No. 0728-206
ATA Code 32-60

Kit No. 23-8008-1 S

SUBJECT: LANDING GEAR - INSTALLATION OF IMPROVED NOSE LANDING GEAR LIMIT SWITCH

EFFECTIVITY: BEECHCRAFT A24R, serials MC-2 through MC-95;
A24R and B24R Sierra 200, serials MC-96 through MC-383 except MC-104.

Figure 1. Nose Gear Limit Switch (MC-2 through MC-95)

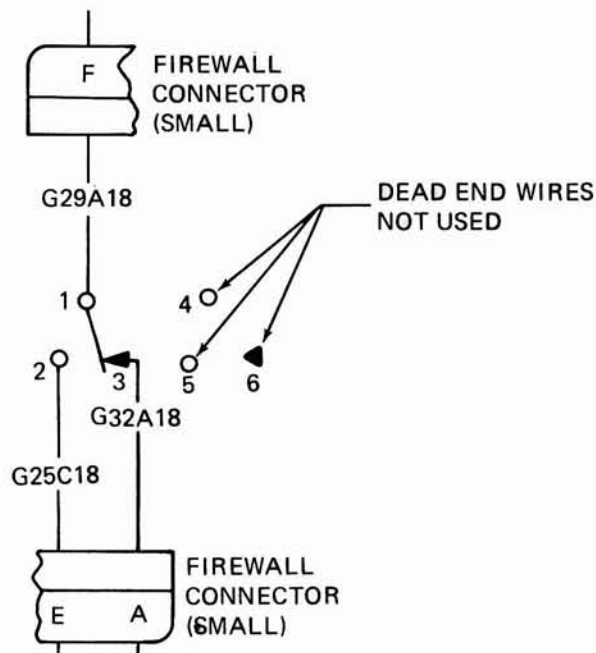
SERIALS MC-2 THROUGH MC-95 (Figure 1.)

- a. Splice wire G29A18 to switch wire No. 1.
- b. Splice wire G25C18 to switch wire No. 2.
- c. Splice wire G32A18 to switch wire No. 3.
- d. Dead end switch wires No. 4, No. 5 and No. 6 and stow the dead ended wires.

Figure 2. Nose Gear Limit Switch (MC-96 and after)

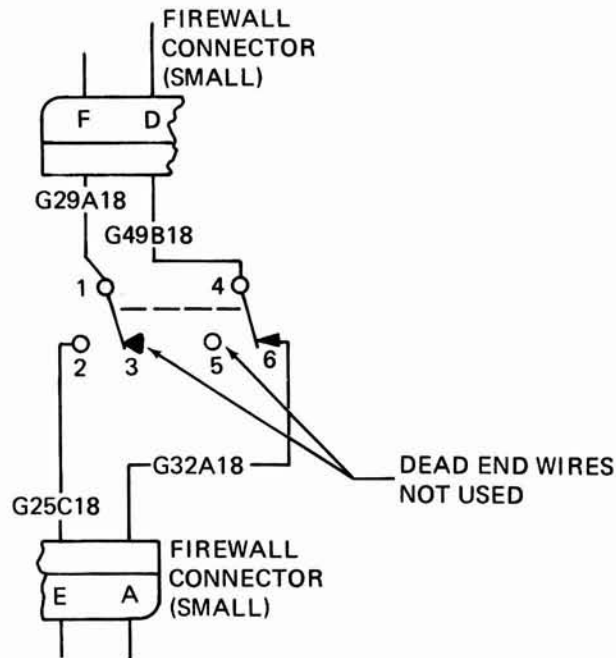
SERIALS MC-96 and after (Figure 2.)

- a. Splice wire G29A18 to switch wire No. 1.
 - b. Splice wire G25C18 to switch wire No. 2.
 - c. Splice wire G32A18 to switch wire No. 6.
 - d. Splice wire G49B18 to switch wire No. 4.
 - e. Dead end and stow switch wires No. 3 and No. 5.
7. Secure the wires to the landing gear assembly with three TY28M nylon clamps.
 8. Turn on electrical power and adjust the nose gear limit switch to actuate the nose gear green light on the instrument panel as the drag link assembly breaks over center.
 9. Secure the lock nuts on the switch assembly with MS20995C41 safety wire. (Obtain safety wire from local sources.)
